DEVNW  
905 AND 925 COTTAGE ST NE SALEM, OR 97301  
BUILDING RENOVATION

City of Salem  
Community Development Planning Division  
555 Liberty St SE, Room 305  
Salem, OR 97301

**City Ref Number:** 20-112373 (Class 3 Site Plan Review)  
20-112375-ZO (Class 2 Adjustment)  
20-112374-DR (Class 3 Design Review)

Below are our responses to the Planning Review Checklist, dated July 31, 2020, along with responses to address additional comments sent by email on the same date, for the above-mentioned project. Original comments precede our responses for reference.

SITE PLAN

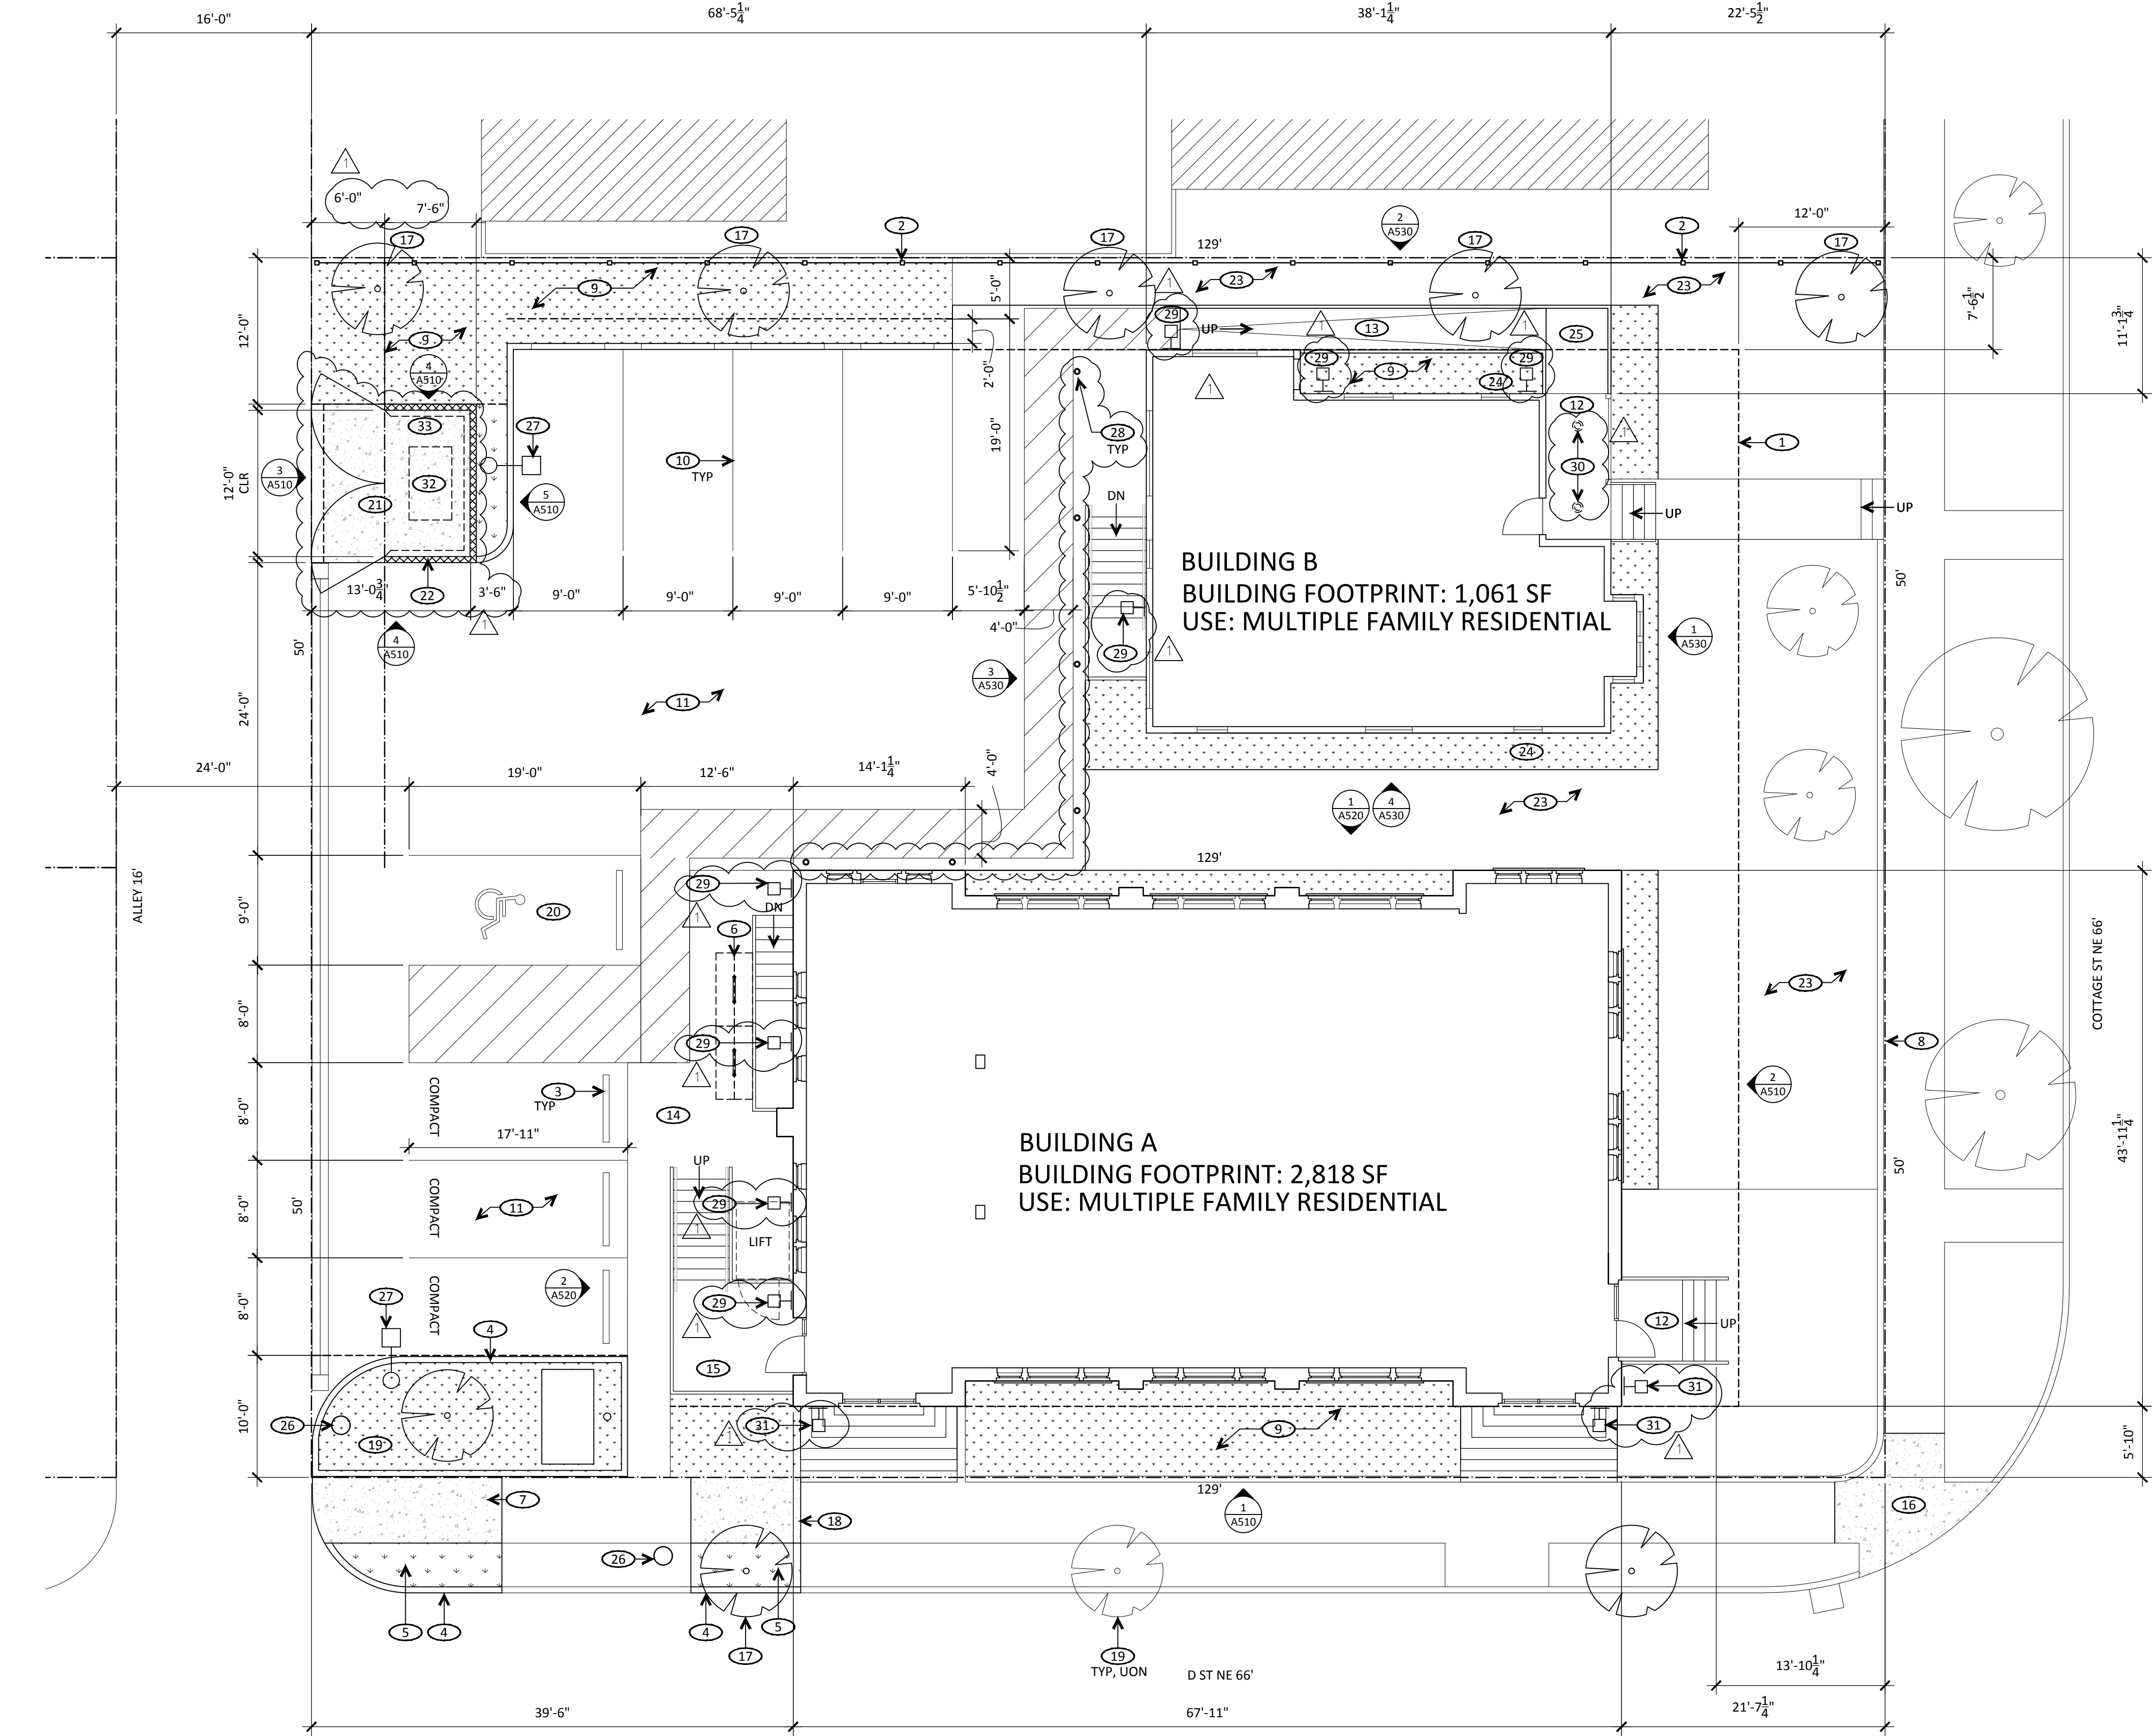
- Please address SCR 800.055. Please provide plans and the size of the receptacles.  
**Response: See Revised Site Plan, A210. Receptacle located within proposed trash enclosure.**

PROPOSED  
LANDSCAPE PLAN

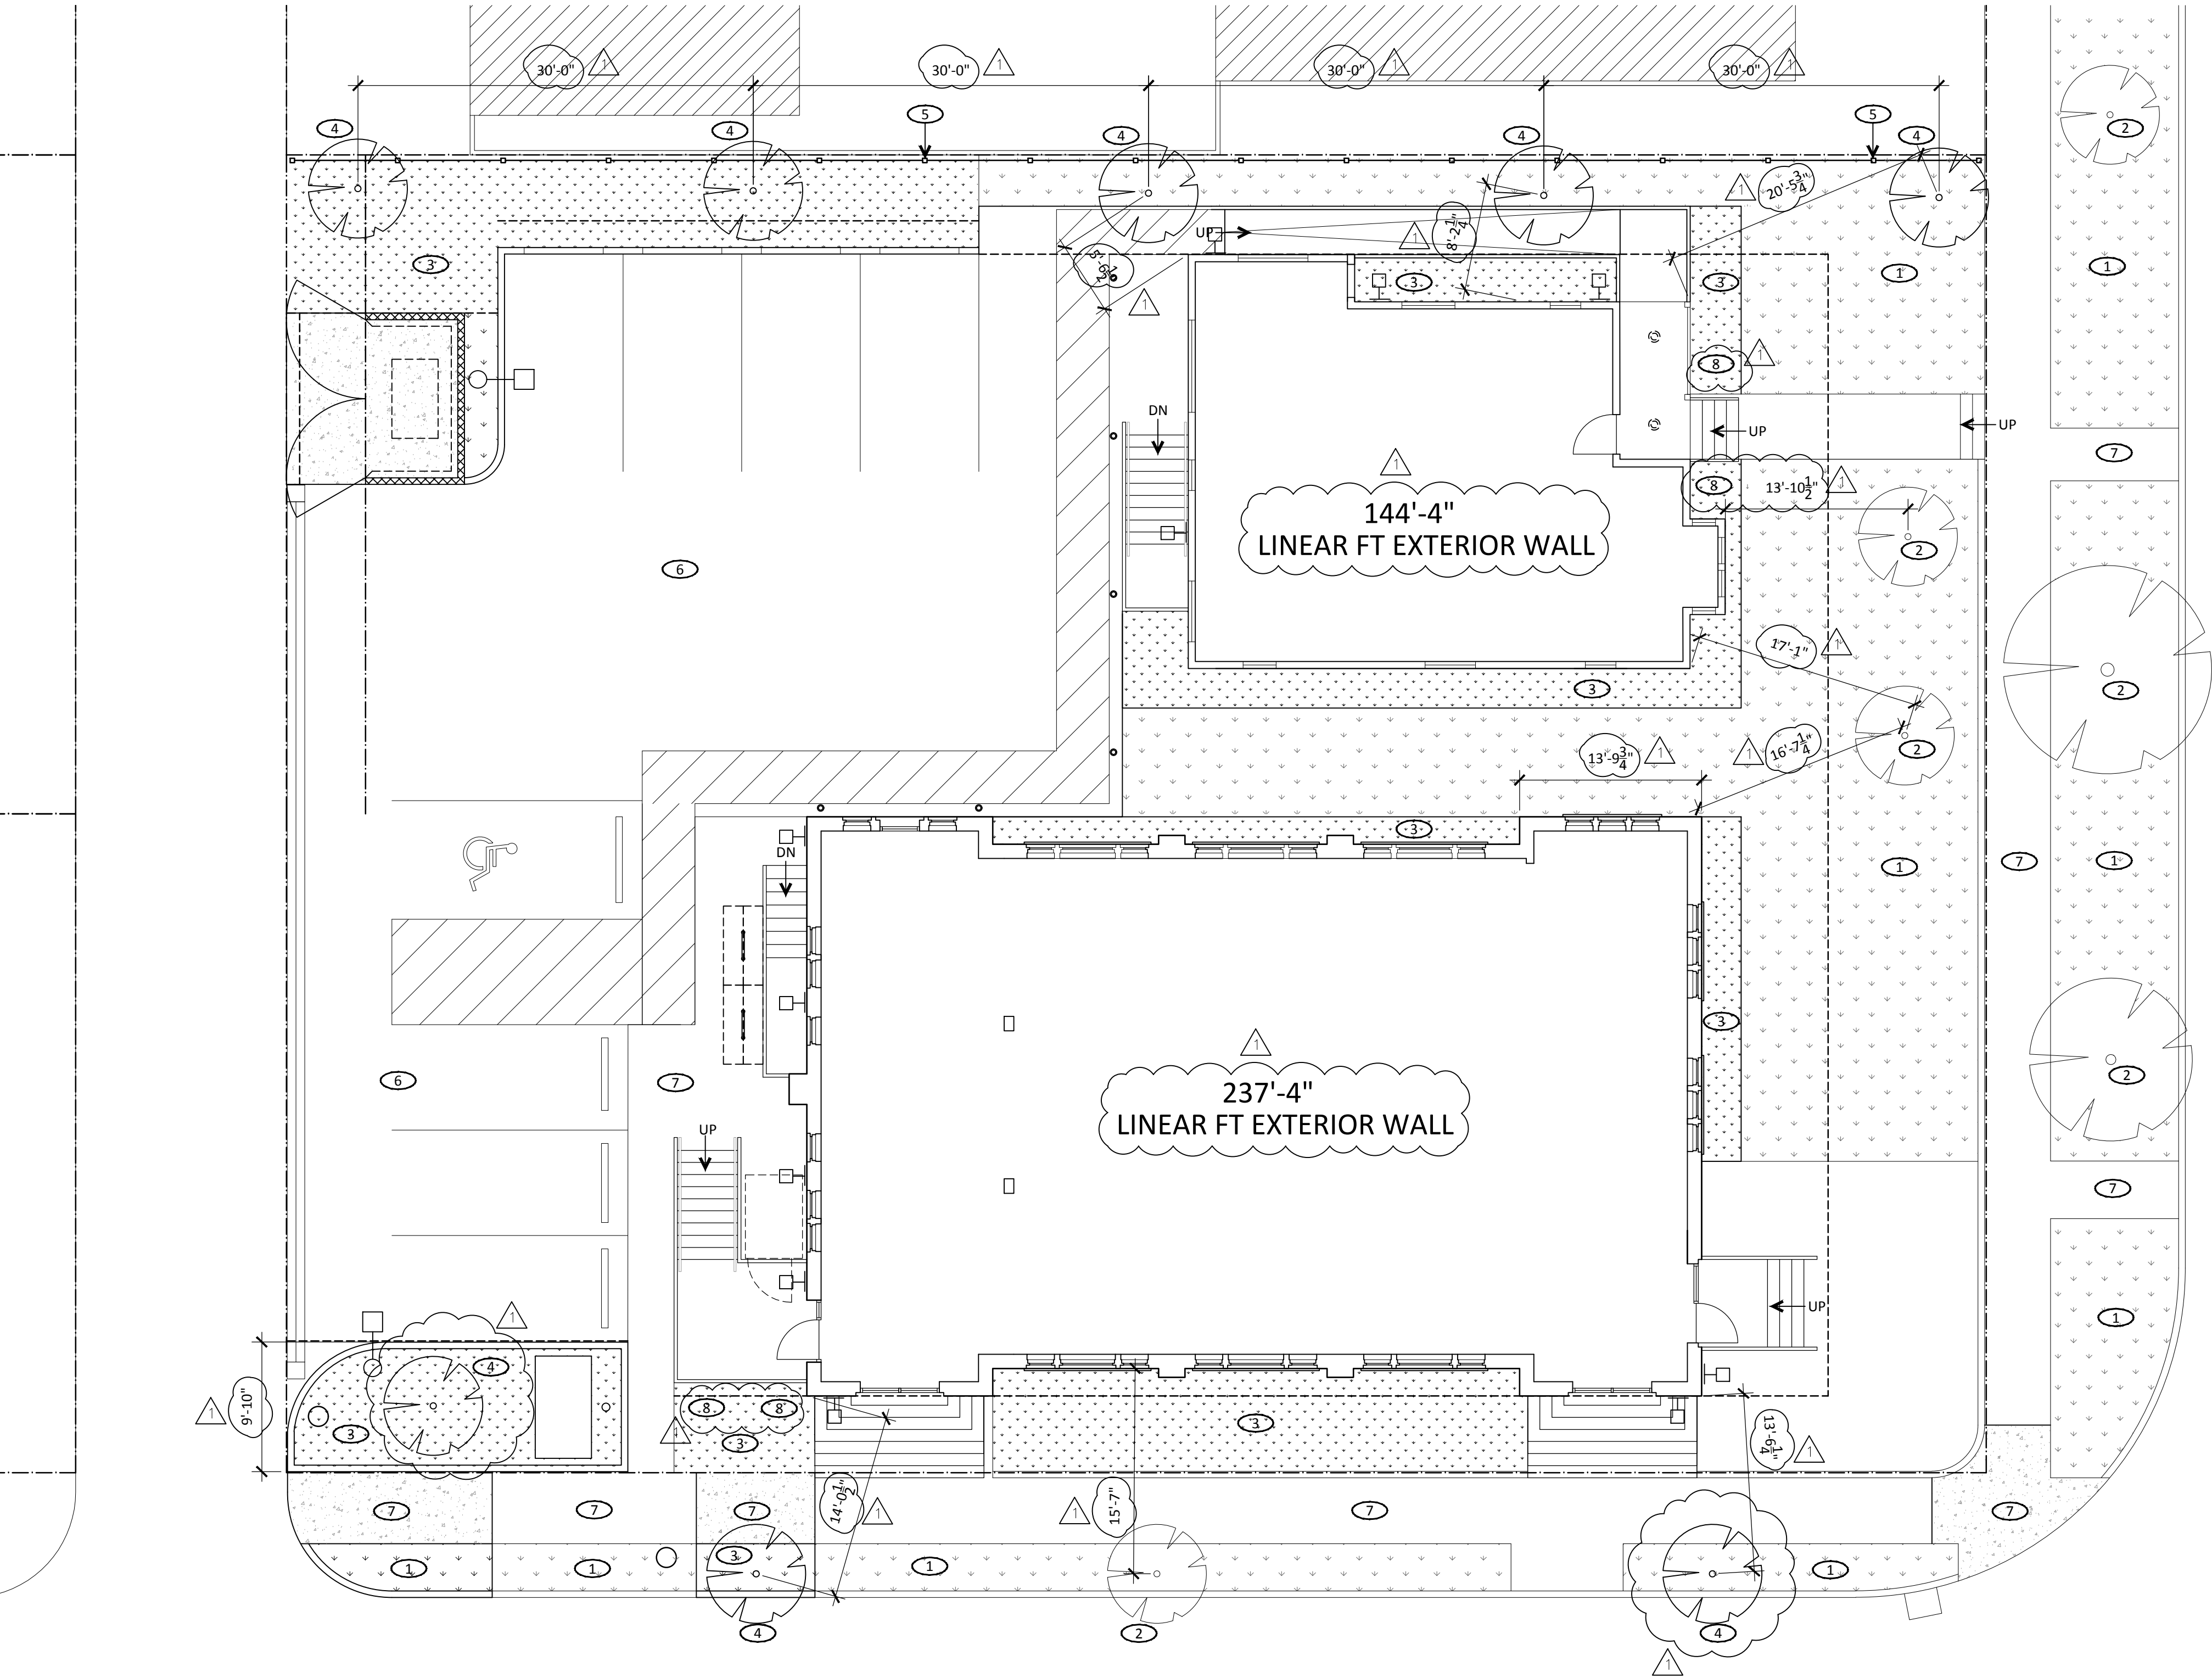
- Please provide a landscaping plan to show that 702.020(b) can be met.  
**Response: See Revised Landscape Plan A320 for landscape requirements.**
- Does not appear each unit has a window on EACH wall in the existing single-family dwelling.  
**Response: See Revised Site Plan Review Written Statement, Adjustment 4.**
- Lighting Plan not provided.  
**Response: See Revised Site Plan A210, (Keynote 27-30) for proposed site lighting.**
- Visually break up building vertical mass; the existing single-family dwelling does not appear to meet this standard on the south side of the building.  
**Response: See Revised Site Plan Review Written Statement, Adjustment 5.**
